1110-Gen COE Eng'r & Des Coves Files
Subject: Lake Ponchartrain, LA & Vicinity Hurricane
Protection Project, H.P. Seabrook Floodwall Extension
(P&S)

REFERENCE OR OFFICE SYMBOL LMNED-FS	SUBJECT REVIEW OF P's FOR LAKE PONT., LA. & VICINITY HURRICANE PROTECTION PROJECT HLP, NEW ORLEANS LAKEFRONT LEVEE - WEST OF IHNC, MISCELLANEOUS GATES, ORLEANS PARISH, LA.	
TO C1 DESIGN Br	FROM C1 F&M Br	DATE 30 JULY 85
		CMT 1 Mr. ESTRADA /1035

REVIEW OF PGS FOR LAKE Pontchartrain
LA. & Vicinity Hurricane Protection Project,
HLP, NEW ORLEANS LAKEFRONT LEVEE
West of IHNC, Miscellaneous GATES

REFERENCE OR OFFICE SYMBOL LMNED-FS/LMNED-FM	SUBJECT Review of Plans & Specifications for Lake Pontchartrain, LA & Vicinity Hurricane Protection Project, HLP, New Orleans Lakefront Levee West of IHNC, Miscellaneous Gates, Orleans Parish, LA
---	--

SECTION A-A DWG. 3 OF 36

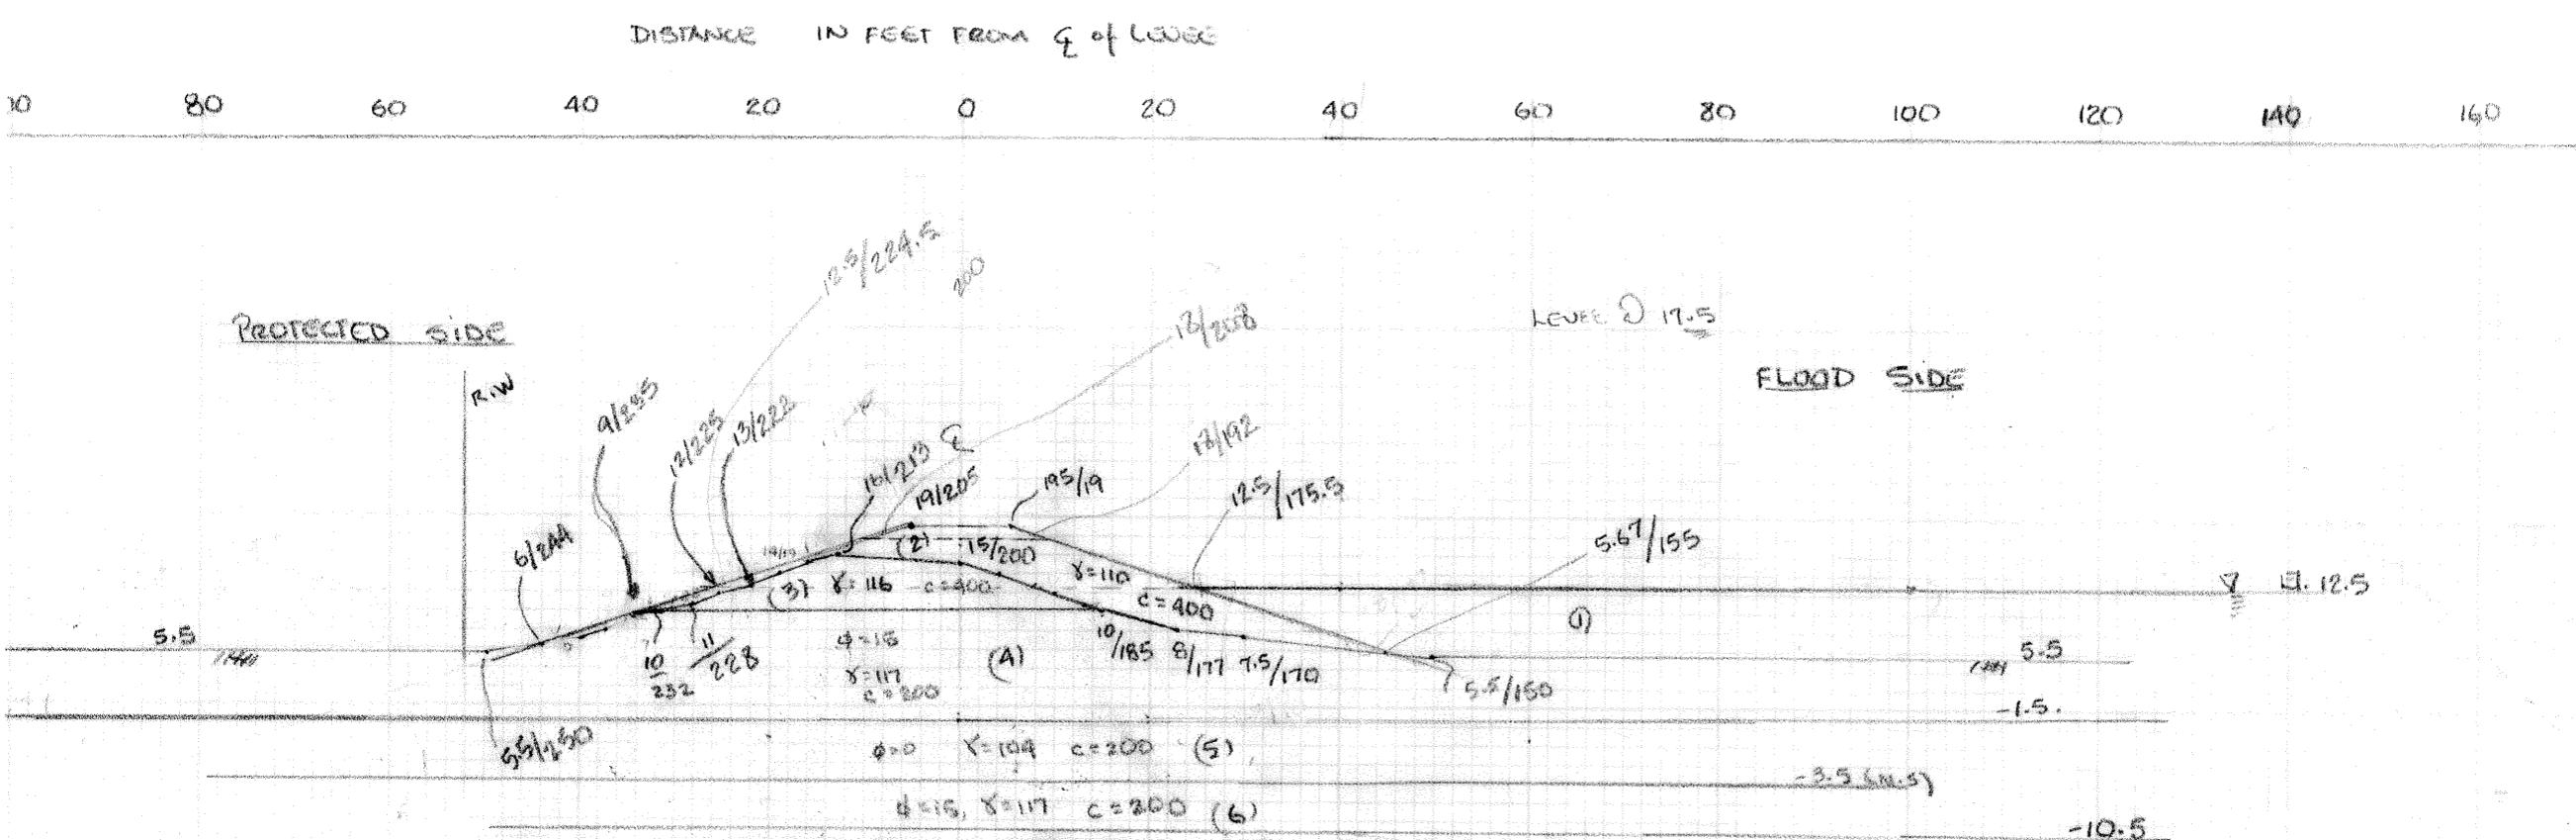
{ a. 21.(b). Do not concur. The levee to be constructed under this contract is for interim protection. A future roadway ramp enlargement, under separate contract, will provide the stability berm required for the final section.

BUILT UP
to 115

141
1043
17.5

{ a. 23. (c). Concur. The stationing for the section was changed to 29+50 B/L, however, the stability berm was not added since a future ^{Roadway} ramp enlargement will provide the required berm.

F.S. OK w/out STAB-BERM (high ground suff.)

SECTION A-A DWG 2 OF 36

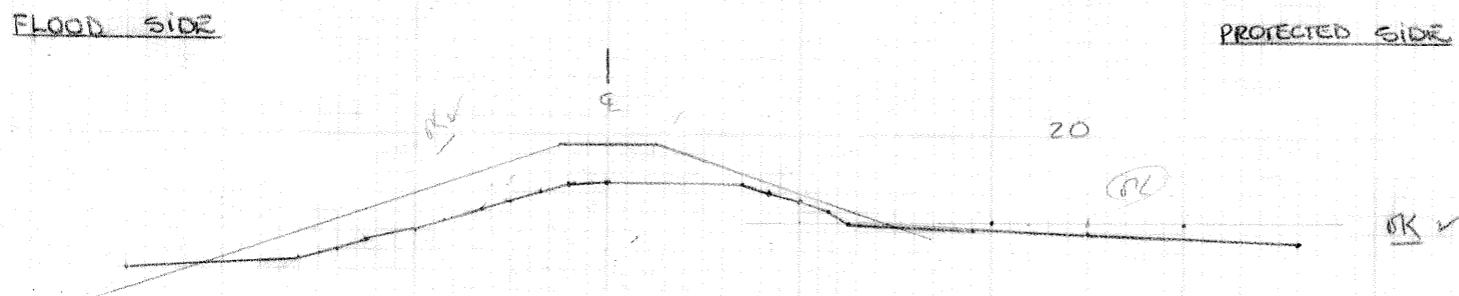
<sup>BUILT UP
TO 17.5'</sup>
<sup>NEEDED
STAB. REQUIREMENT</sup>
a. 24.(a). Do not concur. See a.21.(b).
